UNITED STATES PATENT AND TRADEMARK OFFICE

10/662,751

Office Action Summary	Application No. 10/662,751	Applicant(s) GOSS ET AL.	
	Examiner JUSTIN KRAUSE	Art Unit 3656

DETAILED ACTION

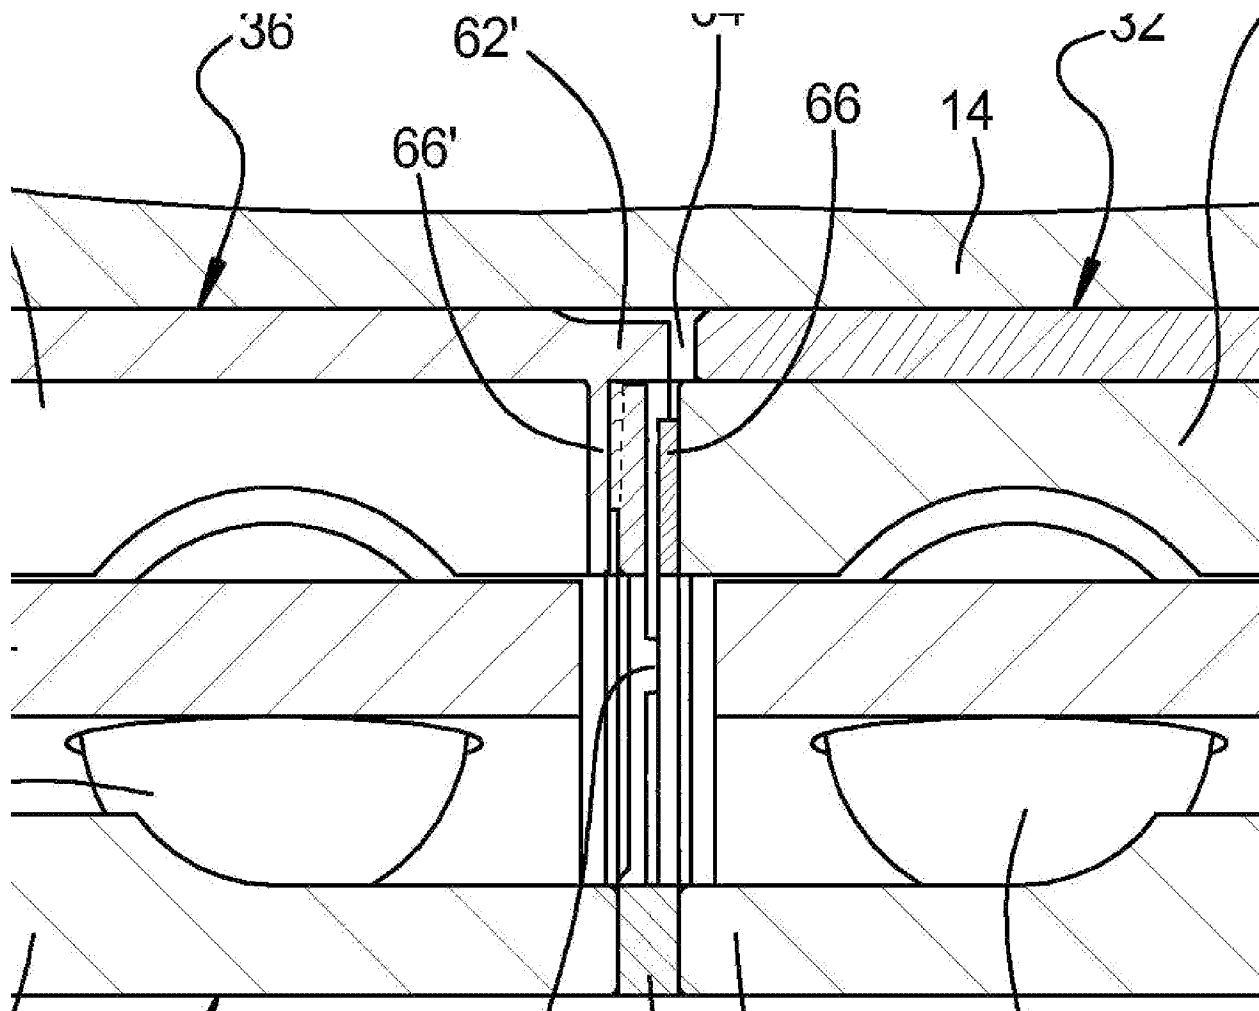
The drawings filed December 1, 2008 are objected to because the cross hatching in figure 6 is incorrect. The drawings filed December 1, 2008 will not be entered.

The following is an enlarged image showing the proper cross hatching which should be displayed in figure 6:
